DOCUMENT CHANGE REQUEST

DCR number 169	Changes required for: General	Originator: S Thacker
Date: 2005/04/14	Date sent: 2005/04/14	Organisation: ESA/ESTEC
Status: IMPLEMENTED

Title:	Capacitors Fixed Ceramic Dielectric Type I High Voltage 1.0 to 5.0kV, based on case styles VR,CV &		
Number:	3001/033	Issue:	1

FIGURE 2(a) - VR STYLE

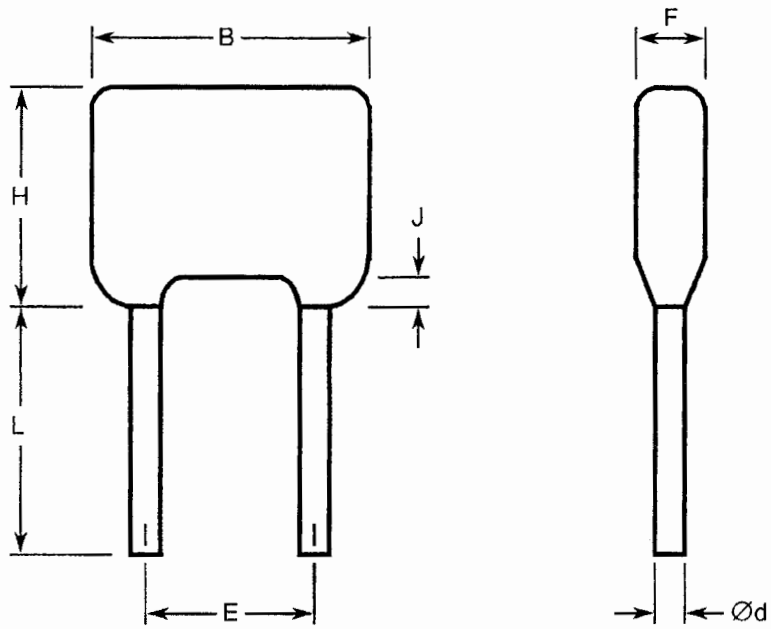
Figure 2(a) - VR style dimensions to be amended as follows:
Variant 01, 02, 03 dimension "Dia d" to be 0.46mm min; 0.56mm max (was 0.51/0.61)

Variant 02 dimension "H" to be 9.62mm max (was 7.62)

Variant 06 dimension "H" to be 19.78mm max (was 17.78)

0.46 0.56 9.62

19.78

Correction of typographic errors.
Specs are now consistent with ESCC 3001/030 & 3001/034 per DCR131 for similar types.
